1989 - 1990 Corvette: Service Bulletin: Convertible Stowage Lid Not Flush With Rear Deck

Number: 90-183-10 - (02/20/1990)

Subject: STOWAGE LID NOT FLUSH W/REAR DECK-PROCEDURE & STEEL RIVETS

Model Year: 1989-90 Y Car Convertible

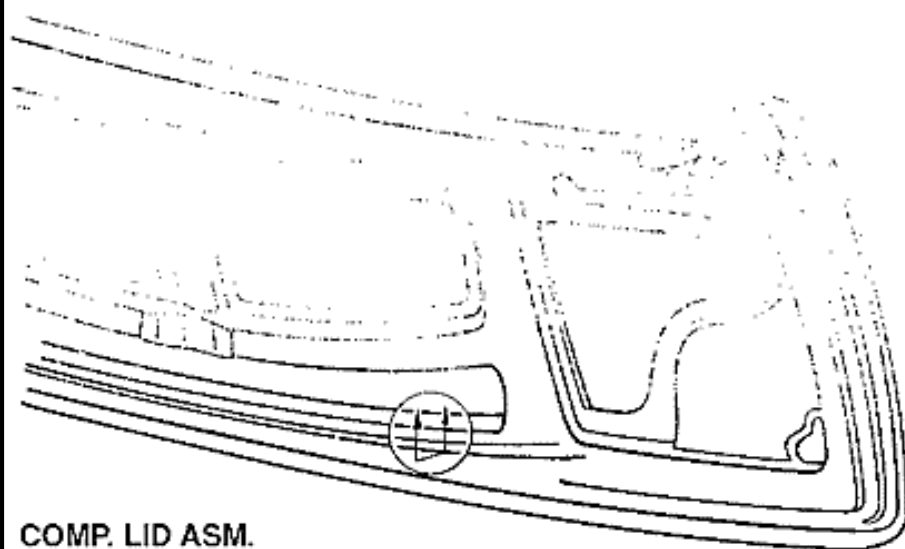
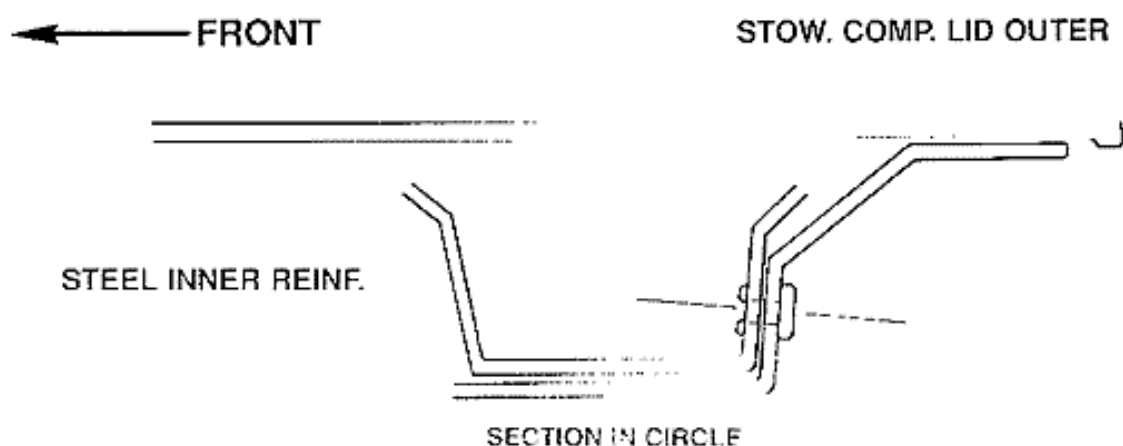
Some 1989 and early 1990 Chevrolet Corvette Convertibles may exhibit a height difference between the stowage compartment lid and the rear deck. This condition may be caused by a lack of adhesive between the steel inner reinforcement and the stowage compartment lid inner panel.

1. Remove the stowage lid as outlined in the Service Manual.
2. Drill 8 (eight) equally spaced 1/8 inch holes through the vertical surface (See Figure 1) of the stowage lid inner panel and the reinforcement.

1. REMOVE STORAGE COMPARTMENT LID FROM VEHICLE AND LAY UPSIDE DOWN ON A CLEAN PROTECTED SURFACE.
2. HOLD WEATHERSTRIP OUT OF THE WAY AND DRILL EIGHT (8) $1/8$ " HOLES IN BACK SIDE THROUGH INNER PANEL AND STEEL REINFORCEMENT (4 HOLES ON EACH SIDE OF CENTER EQUALLY SPACED).
3. INSTALL APPROPRIATE TAPPING SCREW ($5/16$ " LONG) OR STEEL RIVET ($1/8$ " X $1/4$ ").

IMPORTANT: Use a Drill Stop Set at a Depth of 1 inch when drilling these holes in order to prevent damage to the compartment lid.

3. Install 1/8 inch diameter X 1/4 inch long STEEL rivets in the holes.

IMPORTANT: Do not use aluminum rivets as they will not provide the strength necessary to keep the lid from bowing.
